GENERAL SUMMARY

SUM-77 / 277 / 224
VARIOUS

**CULVERT DETAIL
 RAMP A STA. 102+19**

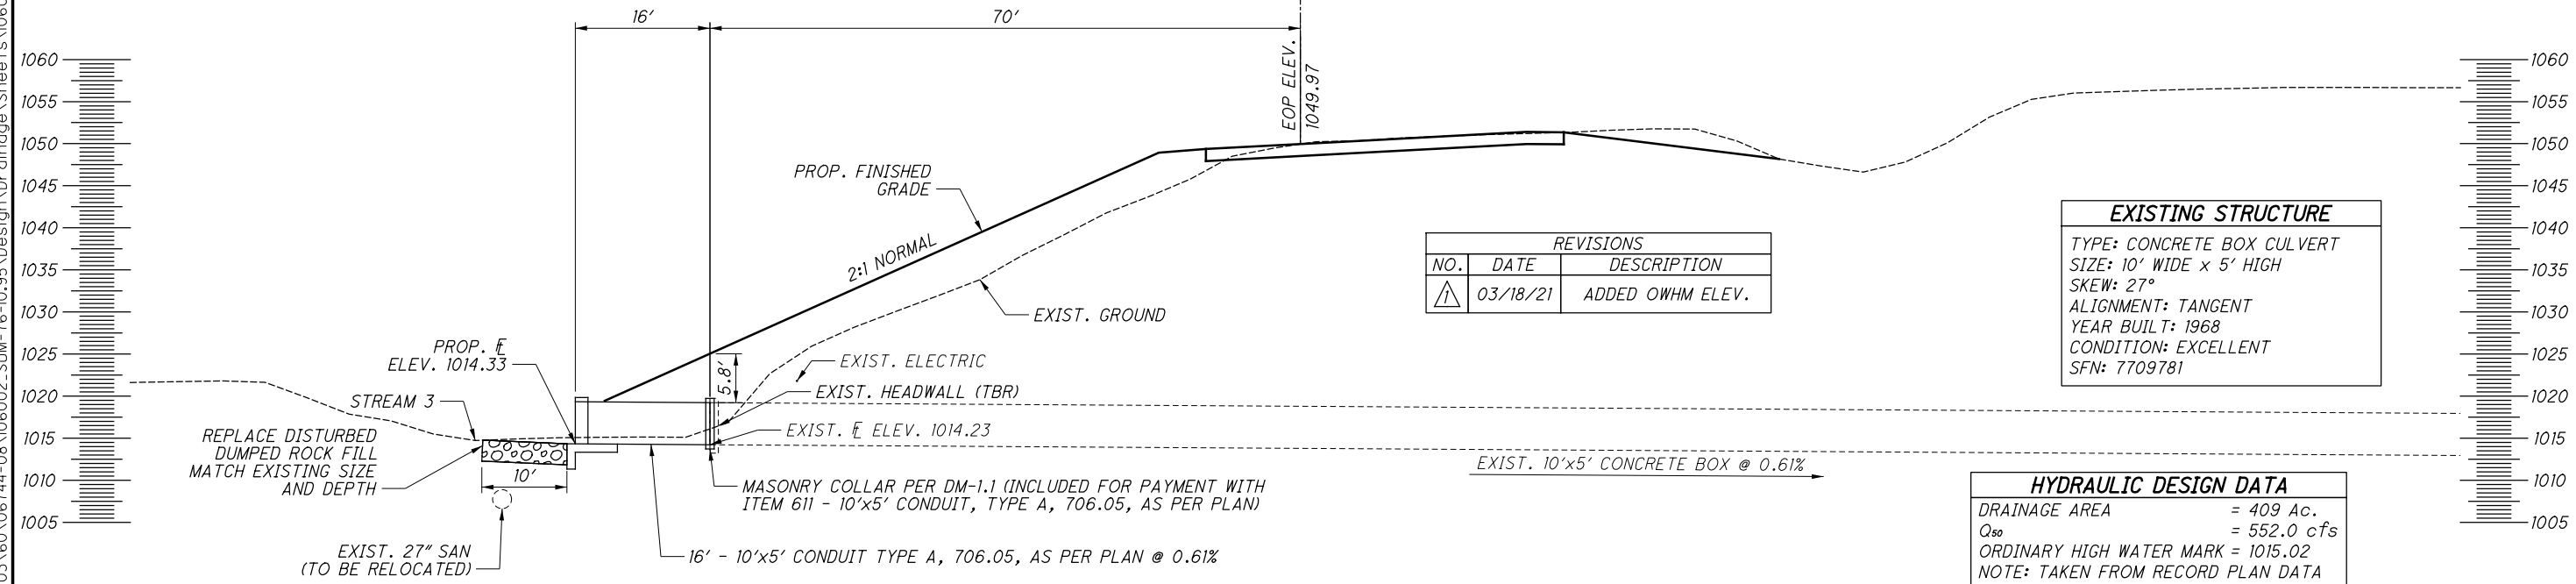
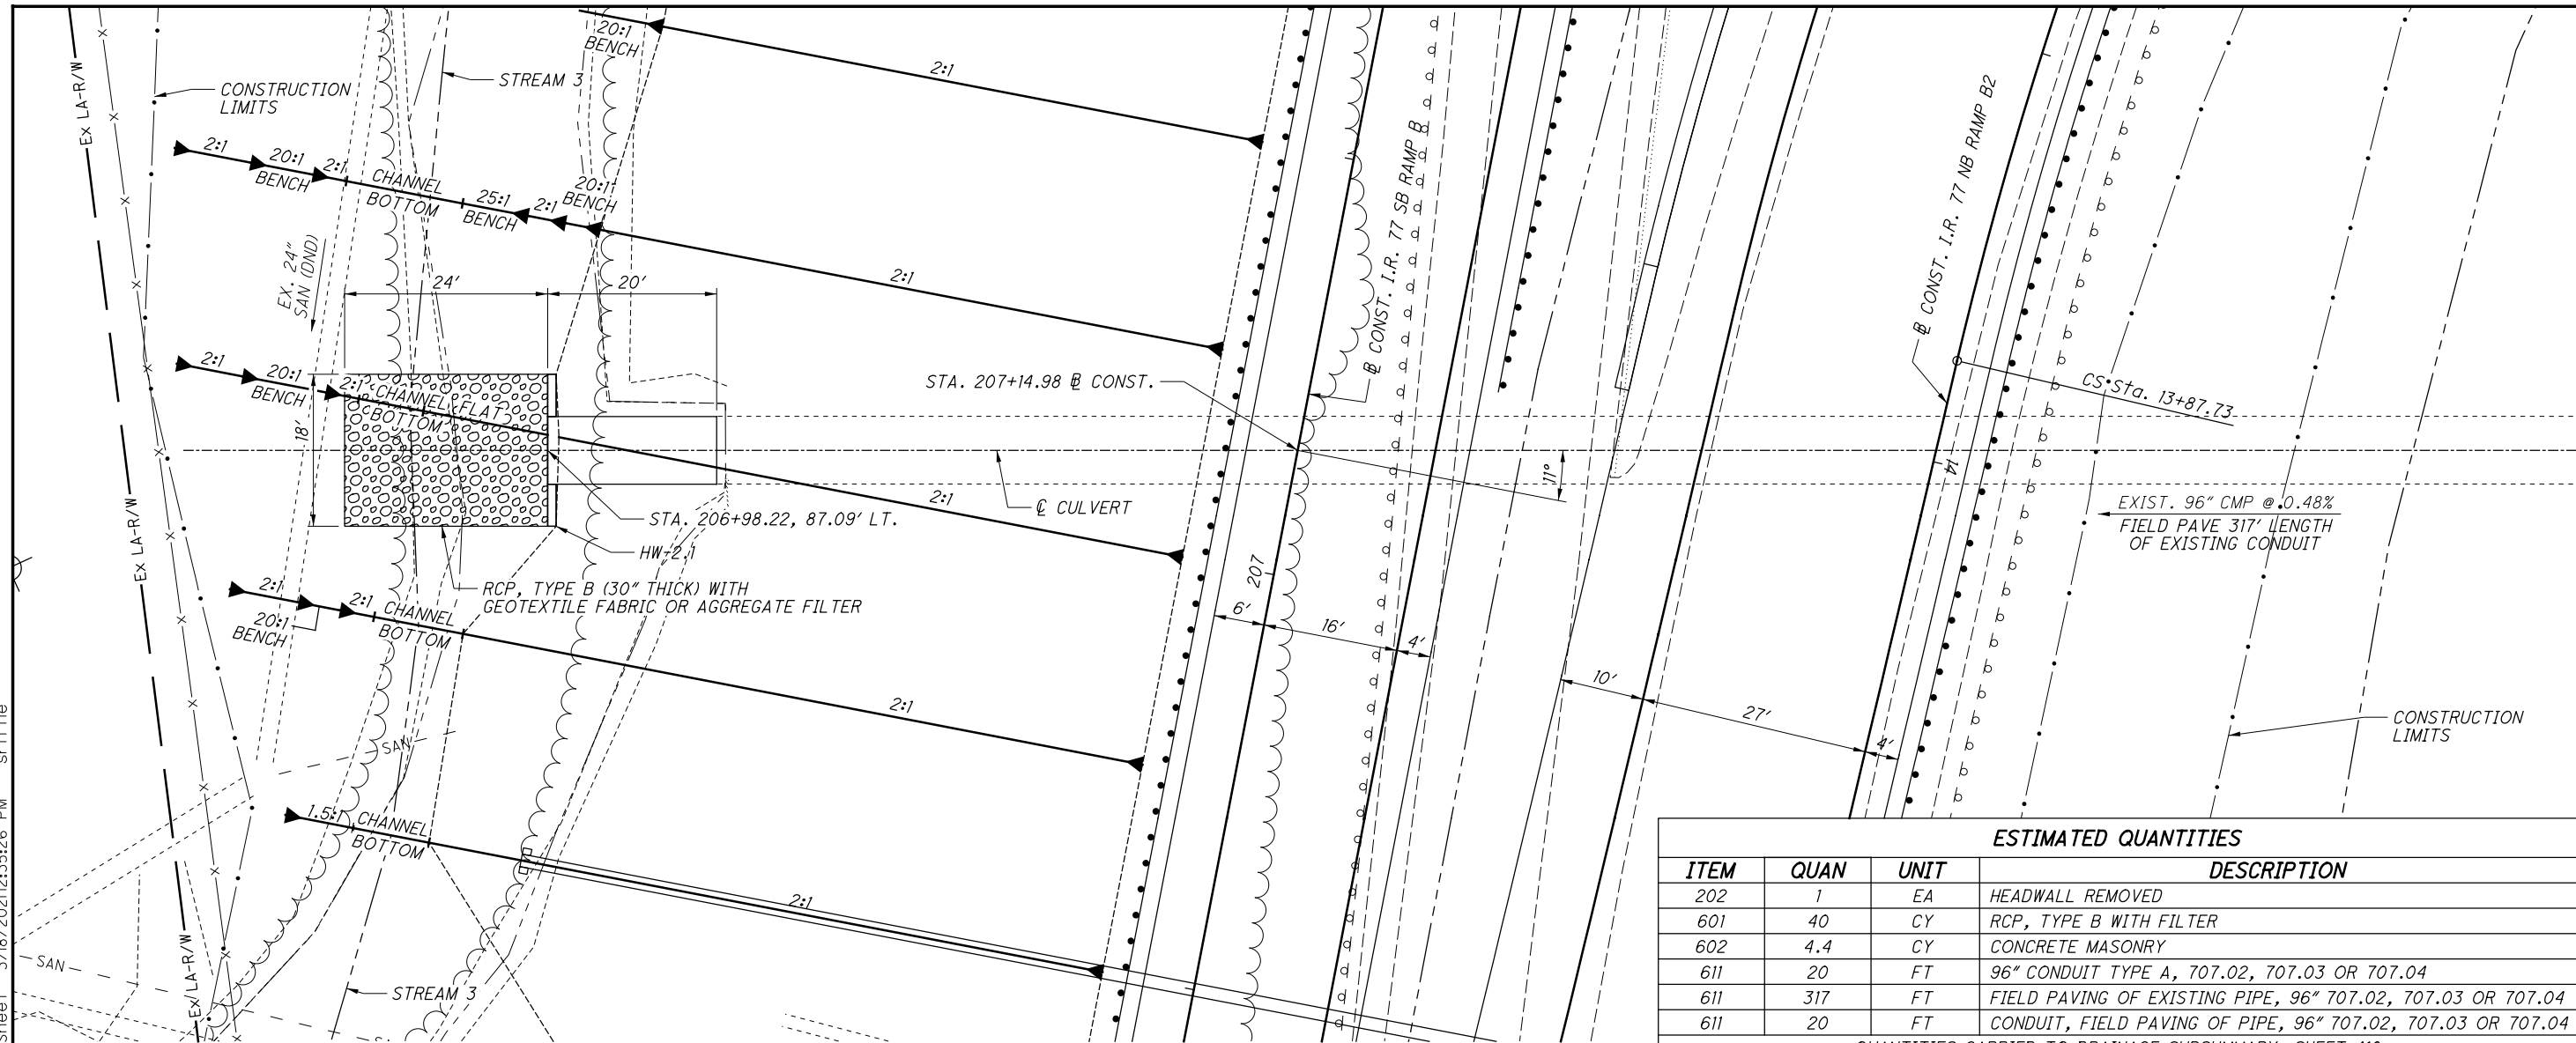
REVISIONS		
NO.	DATE	DESCRIPTION
1	03/18/21	ADDED OWHM ELEV.

HYDRAULIC DESIGN DATA	
DRAINAGE AREA	= 409 Ac.
Q ₅₀	= 552.0 cfs
ORDINARY HIGH WATER MARK	= 1015.02
NOTE: TAKEN FROM RECORD PLAN DATA

CULVERT DETAIL
RAMP B STA. 207+15

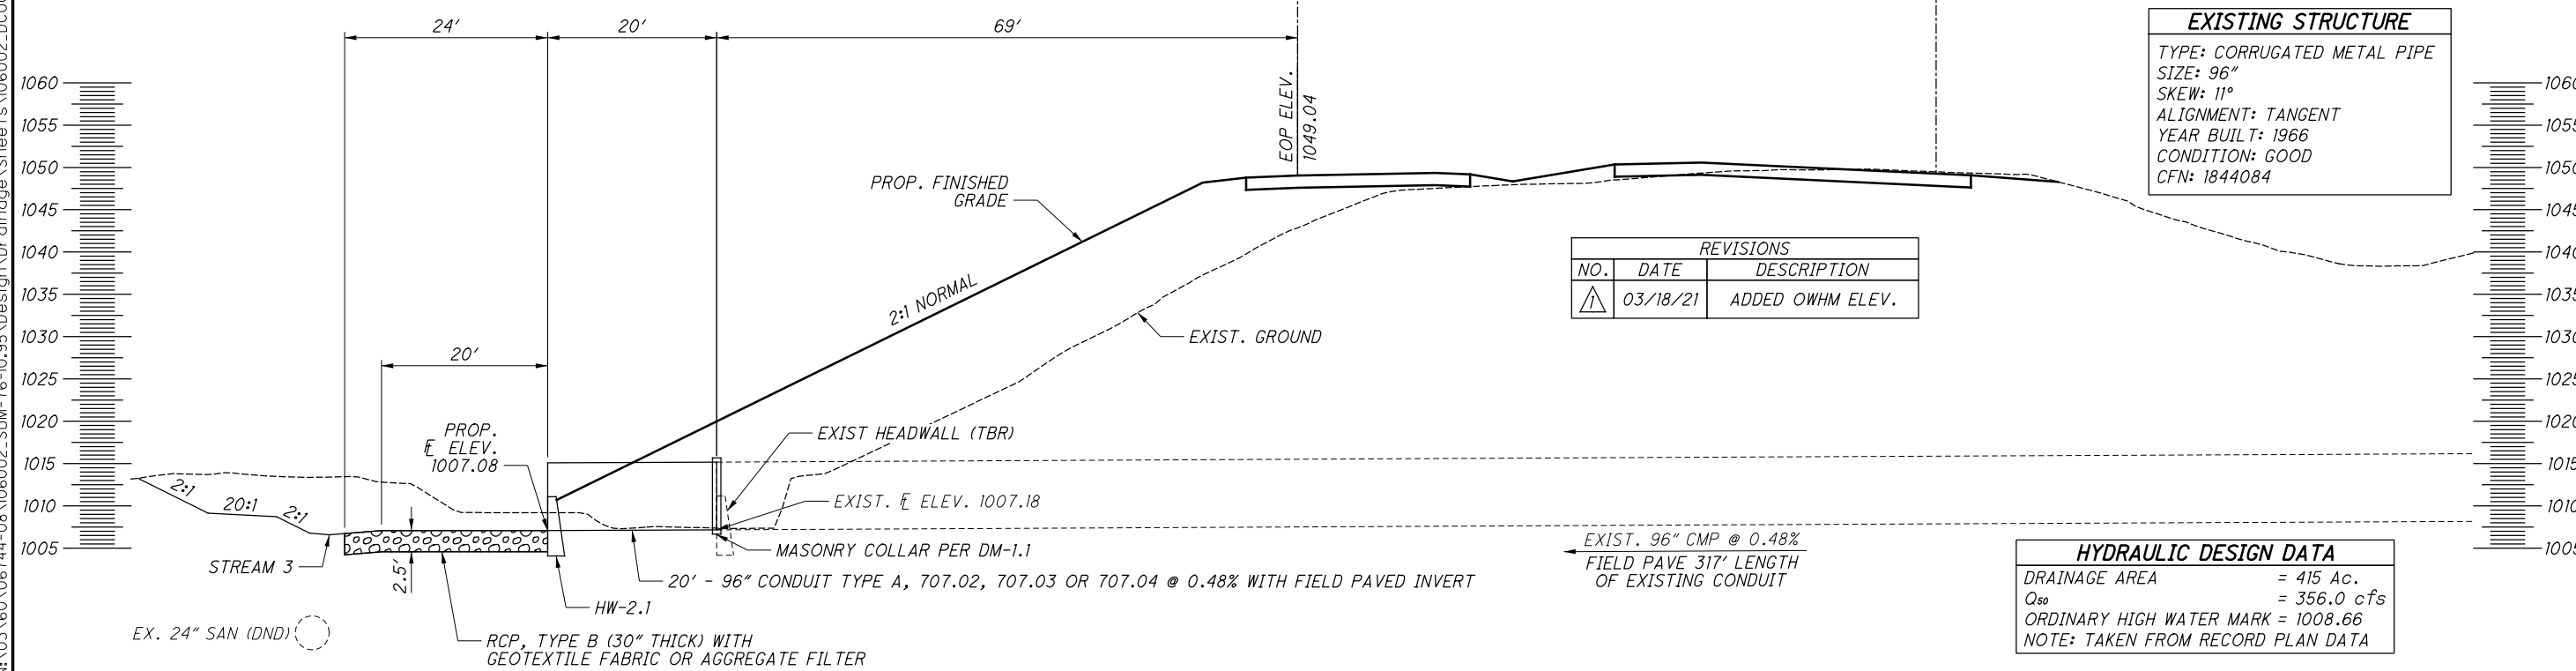
REVISIONS		
NO.	DATE	DESCRIPTION
1	03/18/21	ADDED OWHM ELEV.

HYDRAULIC DESIGN DATA
 DRAINAGE AREA = 415 Ac.
 Q_{50} = 356.0 cfs
 ORDINARY HIGH WATER MARK = 1008.66
 NOTE: TAKEN FROM RECORD PLAN DATA
